Independent Technical Planning Review

Prepared on behalf of Wilpshire Parish Council

Proposed Residential Development at Salesbury View, Wilpshire

Independent Review of the Current Planning Application and Comparison Against the Previous Appeal Decision

Lancashire County Council – Winter Service Policy

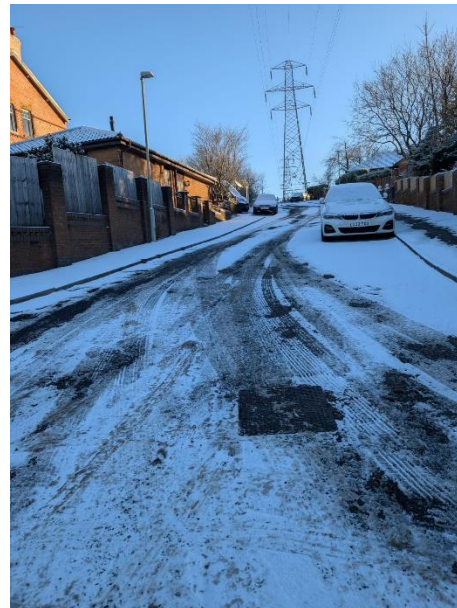
Lancashire County Council publishes an interactive gritting map showing the county's primary and secondary precautionary gritting routes together with grit bin locations. The Council confirms that only priority routes are routinely treated and that it is not possible to grit every road in Lancashire. Priority routes principally comprise motorways, A roads, B roads, routes serving hospitals, emergency services, important public transport corridors and single routes into villages.

No evidence has been identified within the submitted Transport Assessment confirming whether Salesbury View forms part of Lancashire County Council's precautionary gritting network. Accordingly, no reliance can be placed on routine precautionary gritting when assessing the site's year-round accessibility.
